**PLANNED UNIT DEVELOPMENT
& SUBDIVISION STAFF REPORT****Date: March 5, 2009****DEVELOPMENT NAME**

Providence Park P.O.B. West Subdivision, Resubdivision of Lot 1, Resubdivision and Addition to Lot 1, Phase 1, Resubdivision of Lot 1

CONTEMPLATED USE

SITE PLAN

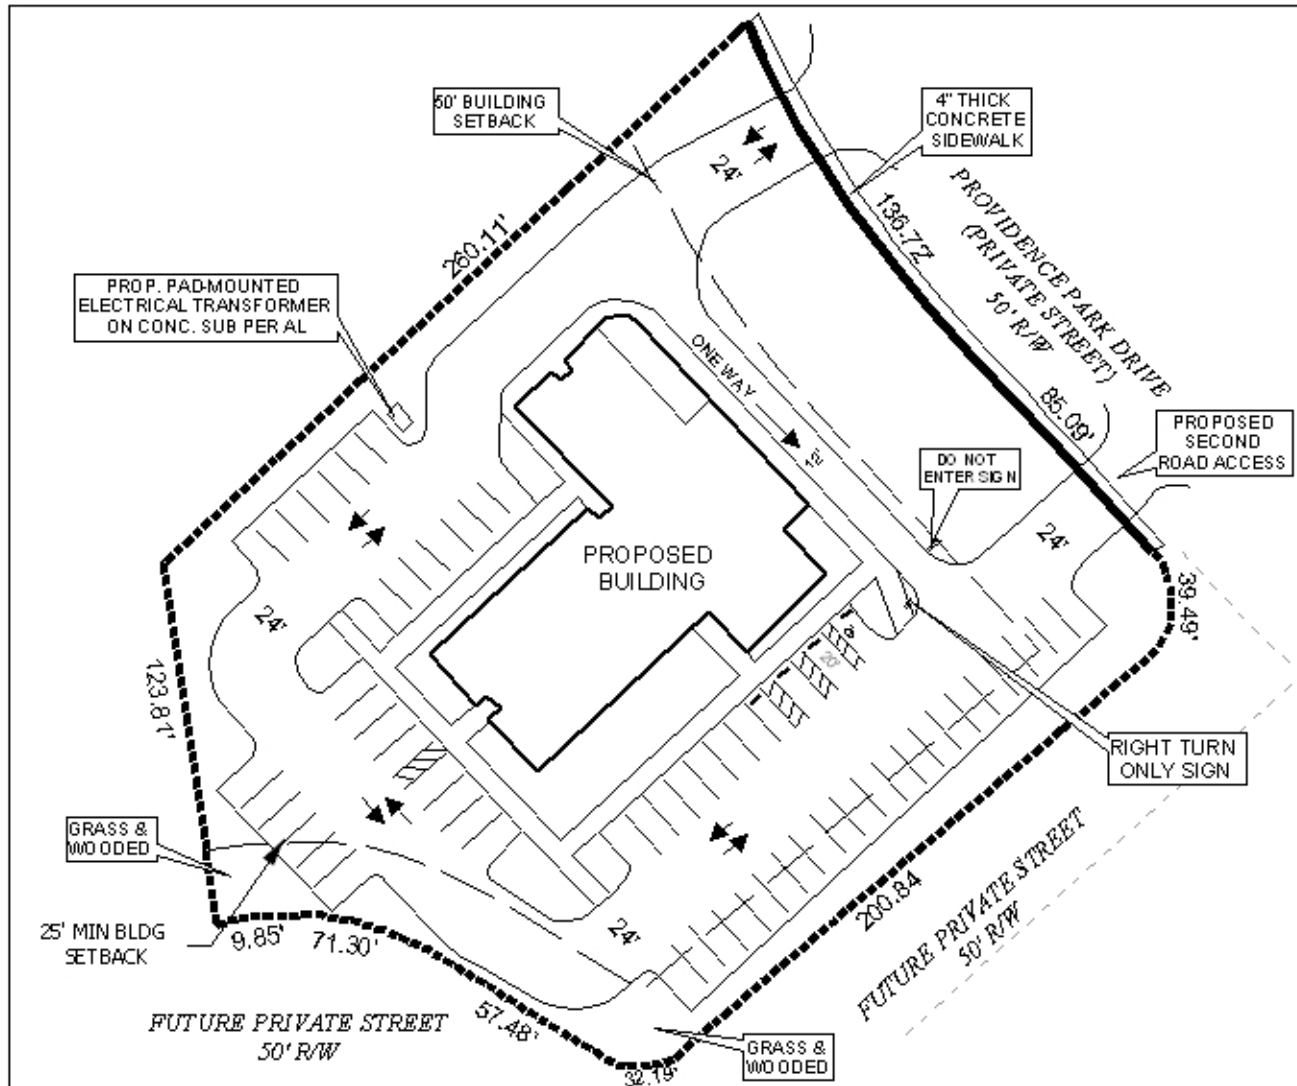
Must comply with all storm water and flood control ordinances. Any work performed in the right of way will require a right of way permit. Rip rap or other appropriate energy dissipation measures will be required at the outfalls labeled E and J on the submitted plans.

The plan illustrates the proposed location of the medical office building, parking and landscaping. Per the requirements of the Planning Commission's April 2008 approval, the site is limited to one (1) curb-cut onto Providence Park Drive East and one (1) curb-cut onto the private cul-de-sac. As the private cul-de-sac has not been constructed as of yet, the applicant is requesting the Commission to remove the condition that the site will be built with only one curb-cut to Providence Park East at this time: an additional curb-cut will be provided onto the private cul-de-sac, once it is constructed.

Regarding the proposed Subdivision, the lot should be limited to two curb-cuts, with the size, design and location to be approved by Traffic Engineering, and in conformance with AASHTO standards. If the location should change due to the location of the curb cuts by Traffic Engineering, two copies of the revised site plan should be submitted to Urban Development for the Planned Unit Development (PUD) file. The applicant stated that they would have no problem removing this curb cut if a curb would be allowed to the future private street when this road is constructed.

- 1) compliance with Engineering comments (*Must comply with all storm water and flood control ordinances. Any work performed in the right of way will require a right of way permit. Rip rap or other appropriate energy dissipation measures will be required at the outfalls labeled E and J on the submitted plans.*);

- 2) placement of a note on the Final Plat stating that the lot is limited to two (2) curb-cuts, with the size, design and location to be approved by Traffic Engineering and in compliance with AASHTO standards;

- 3) placement of a note on the site plan stating that the lot is limited to two (2) curb-cuts, with the size, design and location to be approved by Traffic Engineering and in compliance with AASHTO standards;
